Central Zoo Authority

Sub:- Layout Plan of Ambardi Wildlife Interpretation zone and design of proposed construction of Animal Upkeep Centre, Visitors' gate and emergency gate and design of proposed strengthening of toe wall of perimeter fence at Ambardi Wildlife Interpretation zone (Ambardi Safari Park)-Reg.

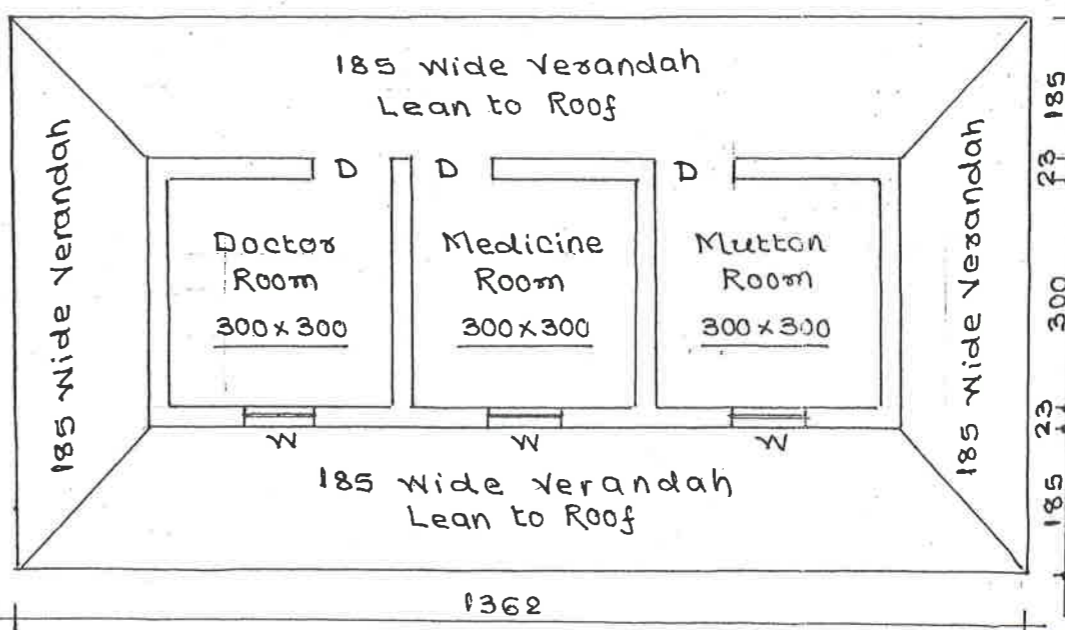
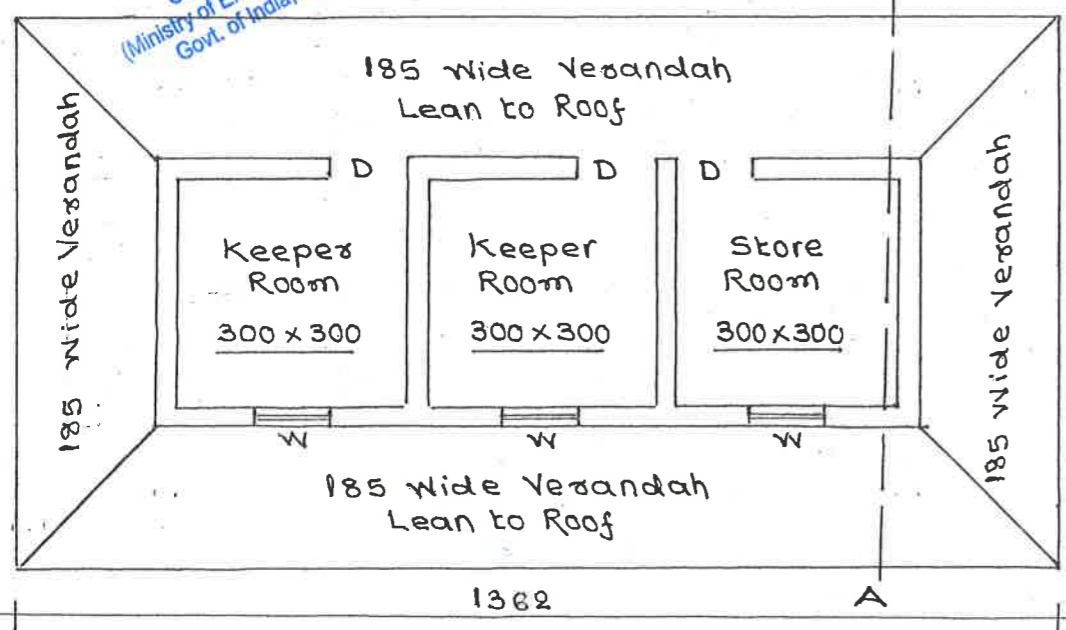
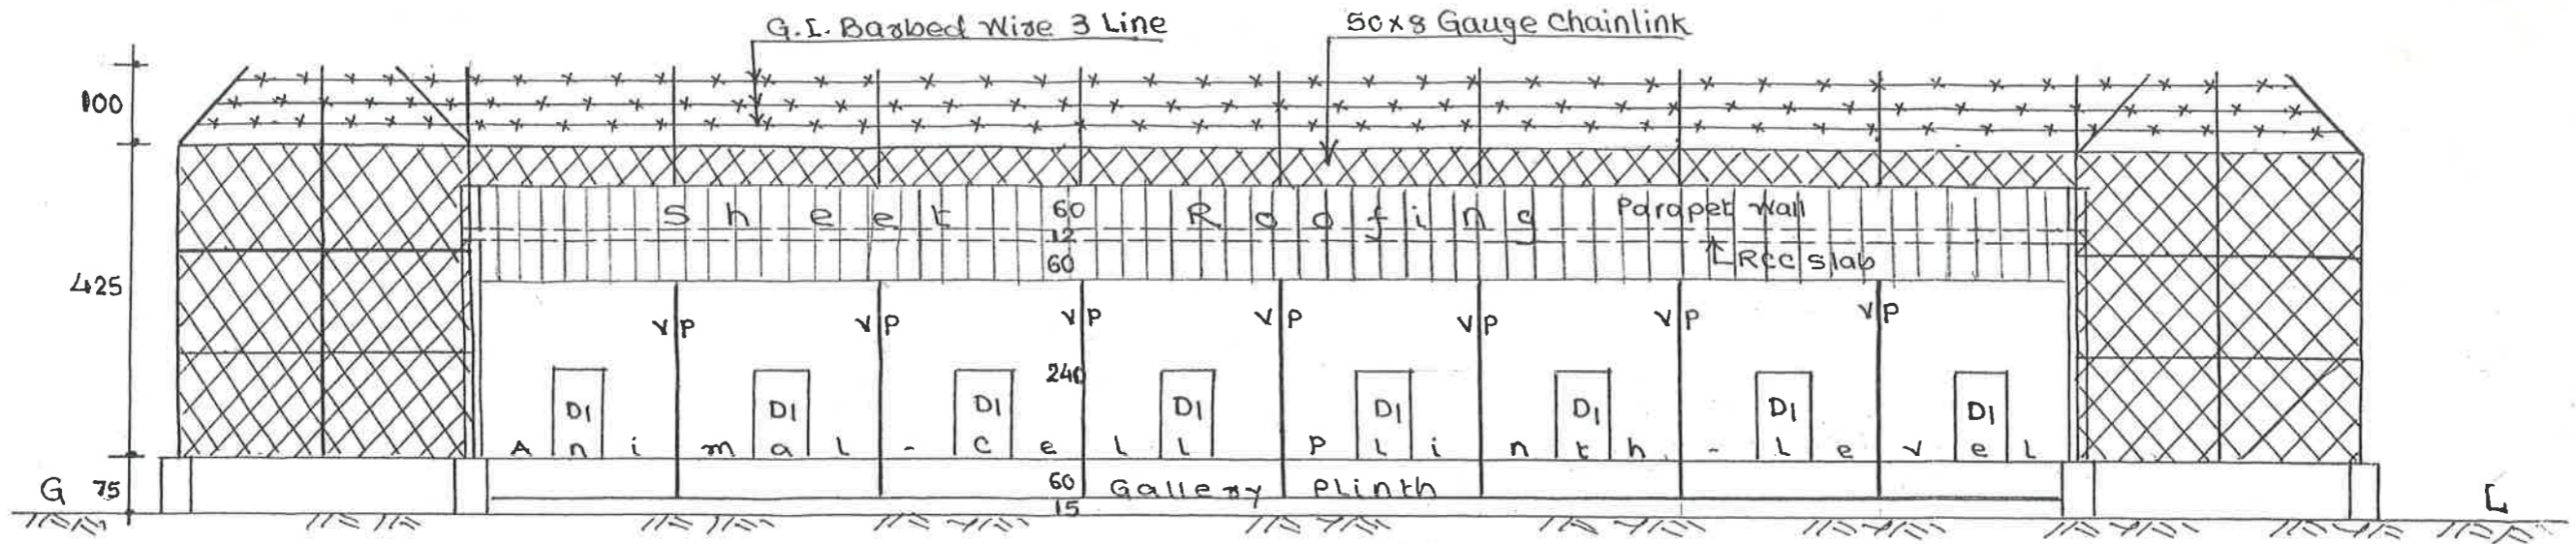
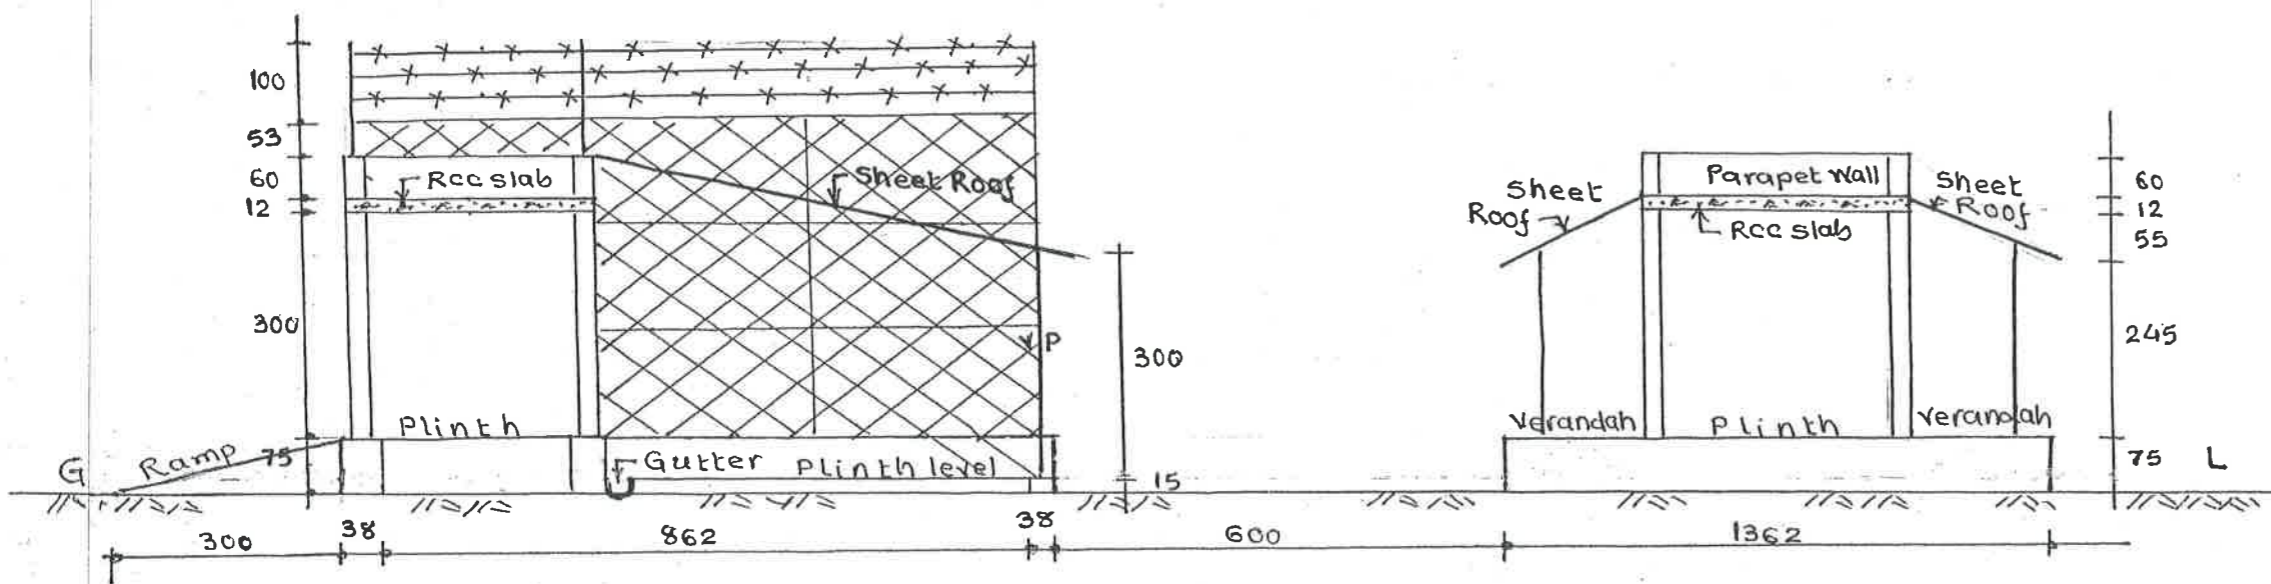
1. Width of keeper's gallery is too much. Gallery with 3 meter width should be sufficient.
